Access Compliance Report Public Rights-of-Way (Curb Ramps)

Main Street: KELLOGG_DR Cross Street: SHADOW_HILL_DR Location: SW

ADA ID: RPAT210922132010 Ramp Type: Type 1 - Perpendicular Diagonal Initial Pass/Fail: Fail Overall Compliance: No Severity Score: 30

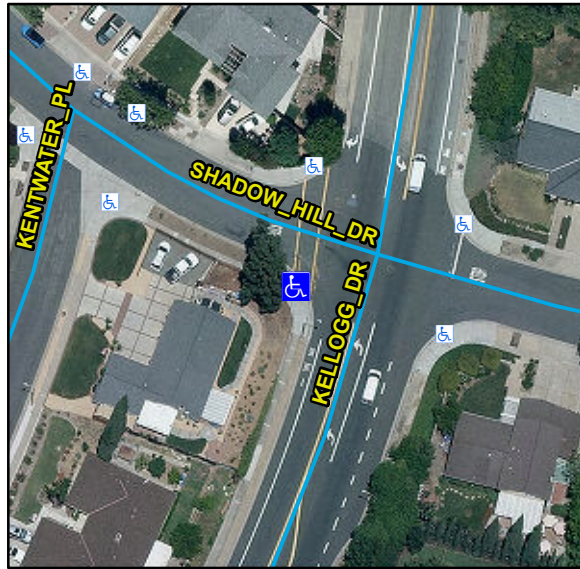
R304.2.2, R204.3, R304.5.3, STD 1115

Remove & Replace Curb Ramp With Two New Directional Ramps or Equivalent.
